# Access Compliance Report

## Public Rights-of-Way (Curb Ramps)

Intersection ID: 44760	Main Street: KINGS_PARADE_BV	Cross Street: N/A	Location: NE
ADA ID: 14CA518F6820	Ramp Type: Perp	Initial Pass/Fail: Pass	Overall Compliance: No
Codes/Mitigation Info/Possible Solution		Field Measurements/Component Compliance	
Severity Score: 10

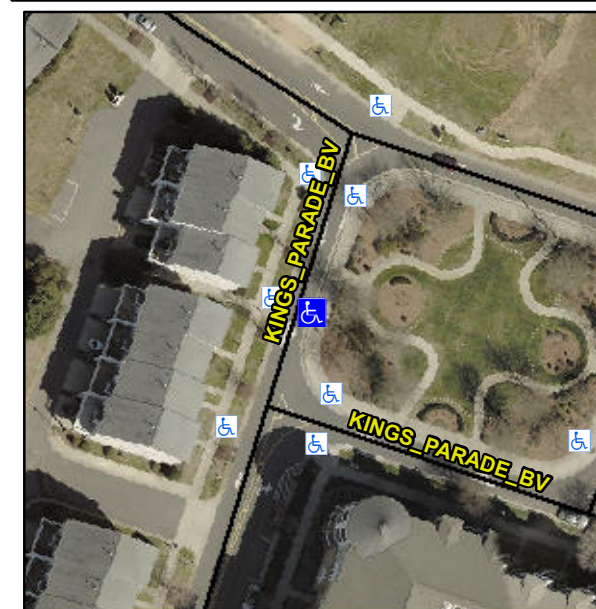
**R304.2.1, R304.2.2-Perp, R304.3.2-Para, R304.5.3**

Compliance	Description	Data	Compliance	Description	Data
N/A	Ramp Length (in)	97.0	Yes	Ramp Slope (%)	7.1
Yes	Ramp Width (in)	49.0	Yes	Ramp XSlope (%)	1.3
N/A	Flare Type LT	Sloped	N/A	Flare Type RT	N/A
N/A	Flare Slope LT (%)	7.9	Yes	Flare Slope RT (%)	3.4
N/A	Flare Traversable LT?	Yes	N/A	Flare Traversable RT?	Yes
No	Landing Length (in)	N/A	Yes	DWS Provided?	Yes
No	Landing Width (in)	N/A	Yes	DWS Contrast?	Yes
No	Landing Slope (%)	N/A	Yes	DWS Length (in)	24.0
No	Landing X Slope (%)	N/A	Yes	DWS Full Width?	Yes
N/A	Landing Curb? (Y/N)	No	Yes	DWS Offset (in)	0.0
N/A	Shared Landing?	No			
Yes	Gutter Ponding?	No	Yes	Gutter Slope (%)	2.2
Yes	Gutter Lip Ht (in)	0.0	No	Gutter X Slope (%)	2.6
N/A	Painted X Walk1?	No	N/A	Painted X Walk2?	N/A
	X Walk 1 Direction	To W		X Walk 2 Direction	N/A
N/A	X Walk 1 Width (in)	N/A	N/A	X Walk 2 Width (in)	N/A
	X Walk 1 Slope (%)	2.5		X Walk 2 Slope (%)	N/A
	X Walk 1 X Slope (%)	2.2		X Walk 2 X Slope (%)	N/A

N/A	Ramp inside XWalk1?	N/A	N/A	Ramp inside XWalk2?	N/A
	Road Slope (%)	N/A	N/A	Clear Space?	Yes
	Road X Slope (%)	N/A	N/A	Clear Space to XWalk (in)	N/A
Yes	Any Obstructions?	No	Yes	Storm Grate/Utility Hazard?	No
	Obstruction Type			Storm Grate/Utility Type	
		N/A			N/A
			Yes	Surface Condition? (G/P)	Good

**Install Landing. Remove & Replace Gutter.**

Total Cost: \$ 1150.00
